**FIRE STATION 74
FD57100020**

ADDENDUM NO. 2

ISSUE DATE: August 13, 2024

ELECTRICAL SITE PLAN
E1.1

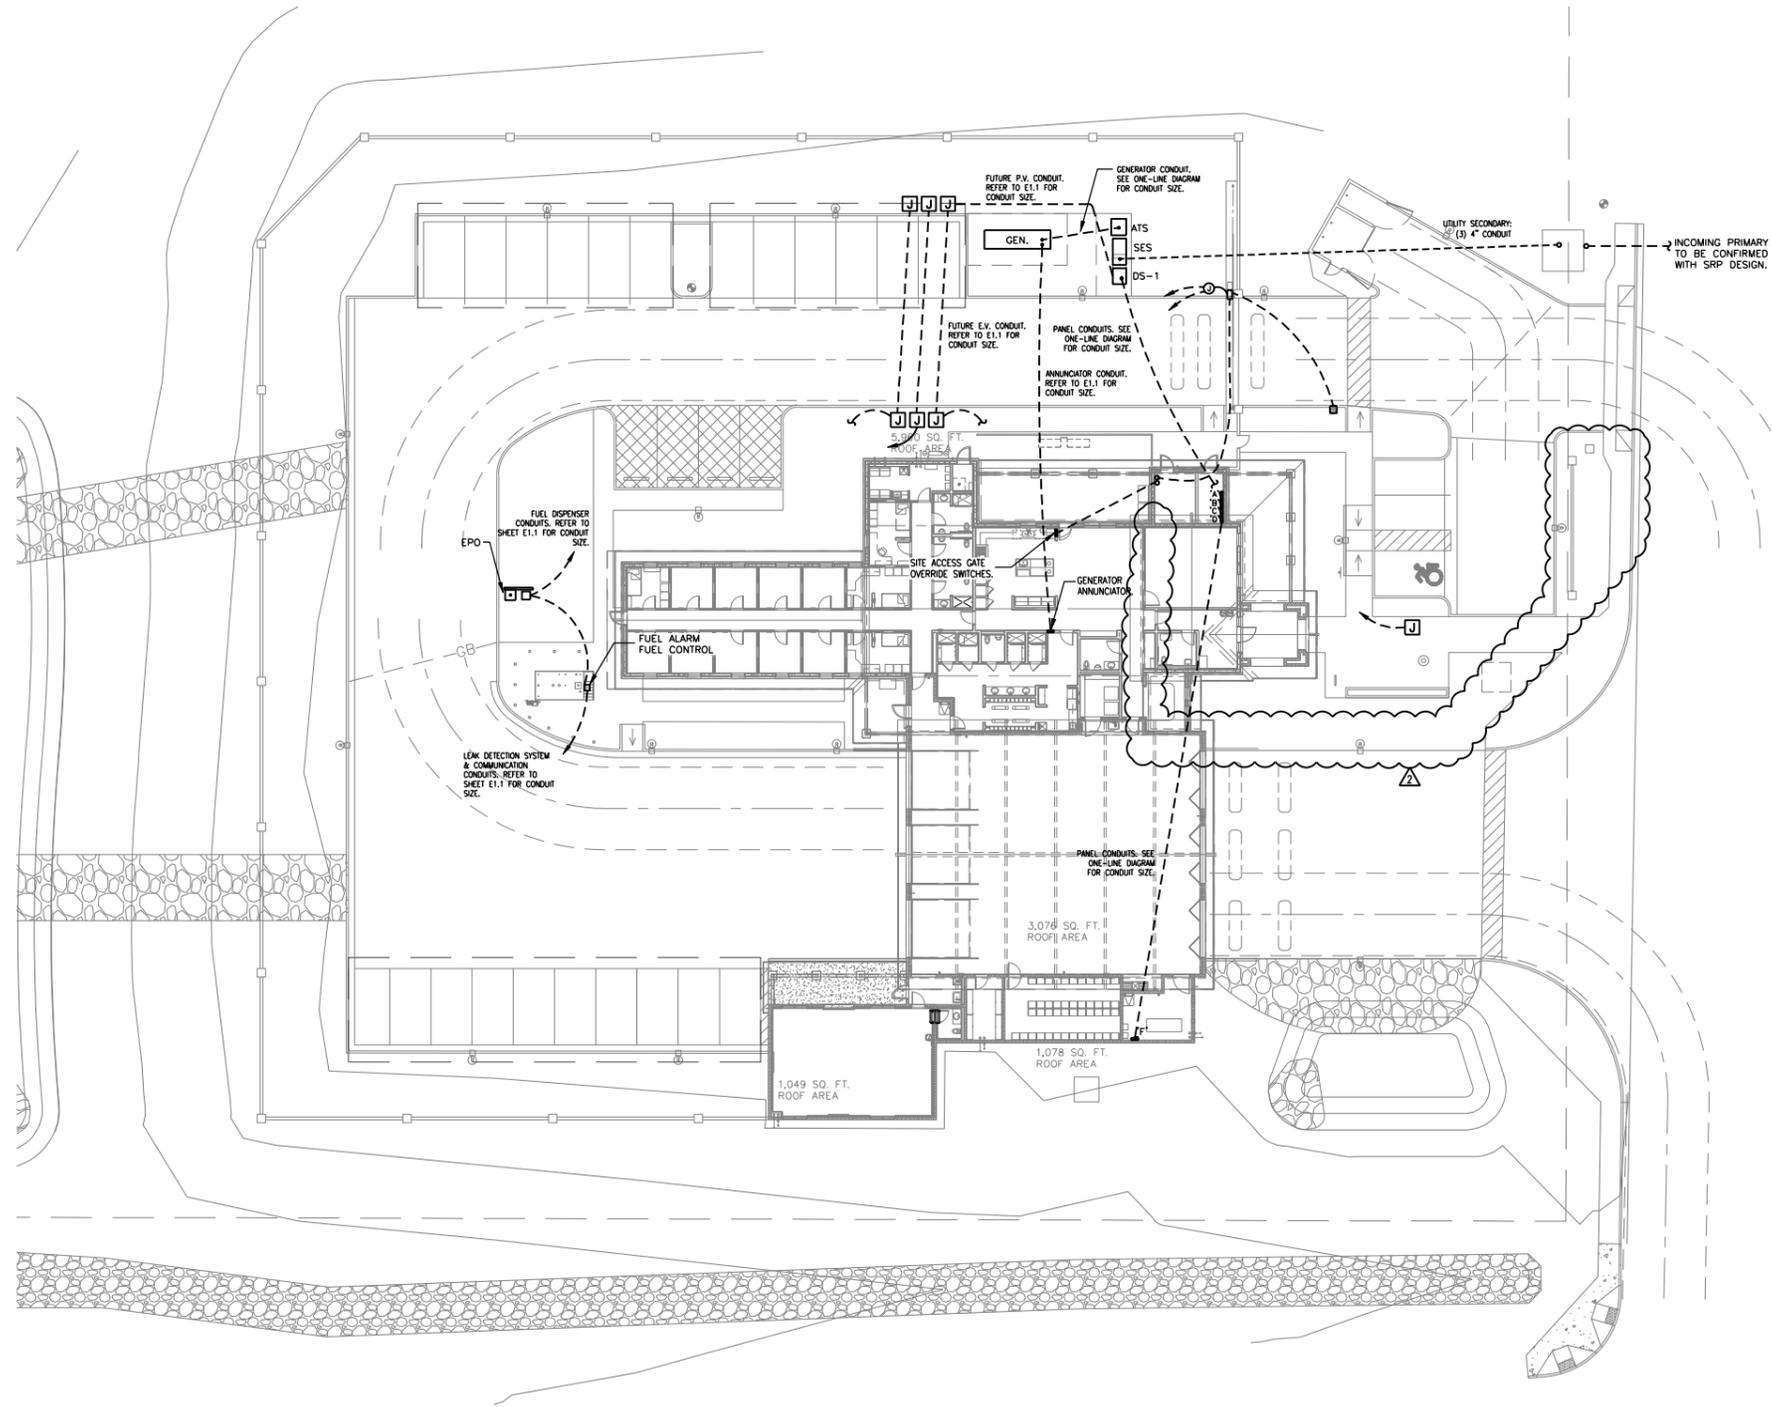
Q1.	On sheet E1.1 attached; the highlighted area says to provide (6) additional 2" conduit from meet me box to cad rm. I am not sure where the CAD rm is located. I believe the Meet Me RM is the IT/ TEL RM? Also note 25. I do not see the existing fiber hand hole on the Civil drawings.
A1.	Communication box formerly on the east side of the building will now be located as shown on the south side of the building. There will no longer be a push button switch to control future traffic controls. Coordinate with civil drawings and communications companies for exact requirements prior to rough in. The Reference to CAD Room should have been referenced to IT/Tel Room No. 137. See attached updated Electrical Sheet E3.1 & E3.2
Q2.	What is the location of second compressor- SC1 (comment 36), other than S.C.B.A. compressor? Refer comment No. 36 on Electrical Drawing E 3.1? We are unable to locate Compressor # 2 location, since there are 2 compressors identified in comment 36 on E3.1.

A2.	Compressor AC-1 has been deleted from this project. Refer to sheet E5.1, please do not include anything associated with compressor AC-1. (disconnect switch in distribution, feeder, disconnect at compressor, etc.) SCBA compressor shall be connected per drawings.
Q3.	Is the generator to be provided by electrical contractor?
A3.	Yes
Q4.	Drawing E5.1, the question related to feeder braker to Panel A. Panel A schedule does not show feeder to Panel B, whereas Drawing 5.1 shows feeder to Panel B from Panel A. Please clarify whether Panel A will be 200A or 400A feeder disconnect, since Panel A is feeding Panel B?
A4.	Per One-Line Diagram, provide 200A switch/fuse, 200A feeder to panel 'A'.
Q5.	Panel schedule 5.2 (drawing 5.2) does not show Panel B fed from Panel A?
A5.	Per note in panel schedule 'A', provide double lugs to feed panel 'B'.
Q6.	Feeder between A to B is missing on Panel Schedule? Is there any other breaker needed?

1. 23224 E1.1 Delta-2.pdf – Updated Electrical Site Plan Sheet
2. 23224 E1.2 Delta-2.pdf – Updated Electrical Site Plan Sheet
3. 24-07-24T3567105RL.pdf – SRP Design Drawings for General Use and Reference
